EXECUTIVE ORDER D-141-2
Relating to Exemptions under Section 27156
of the Vehicle Code

PRESCA DIESEL FUEL SAVER

EVALUATION OF THE CROSSETT AND SON, INC. PRESCA DIESEL FUEL SAVER DEVICE FOR INSTALLATION ON 1988 AND OLDER MODEL-YEAR DIESEL-FUEL MOTOR VEHICLES

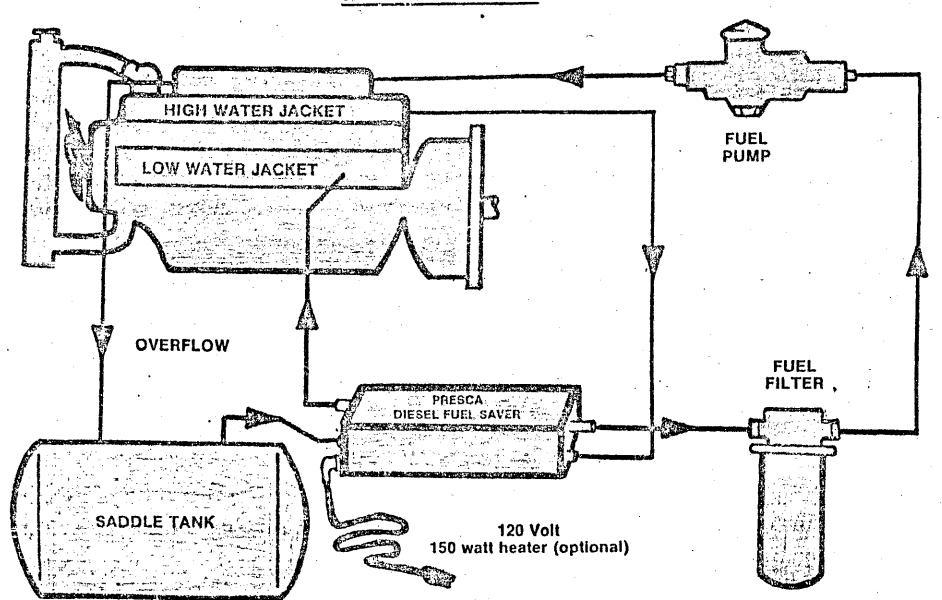
The staff, based on an engineering evaluation of the fuel systems' and engines' design of 1987 and 1988 model-year vehicles, determined that the installation of a fuel heater in series with the diesel engine fuel system will not adversely affect the performance of factory equipped emission control systems.

engine is dependent upon the ambient temperature. If the vehicle is exposed to sub-zero weather temperature, the fuel stored in the fuel storage tank will be at the same sub-zero temperature. Diesel fuel at this temperature tends to congeal. Very poor engine starting will result and may cause unburned fuel to be blown out of the exhaust pipe. With the PDFS device, the diesel fuel from the fuel tank is routed into the heat exchanger where it absorbs heat energy from the hot engine coolant around the coil. The pre-heated fuel may enhance the combustion process in the engine cylinders. An electrical heater rated at 150-watts and 120-volts is inserted in the device for overnight fuel heating to facilitate engine starting in cold weather.
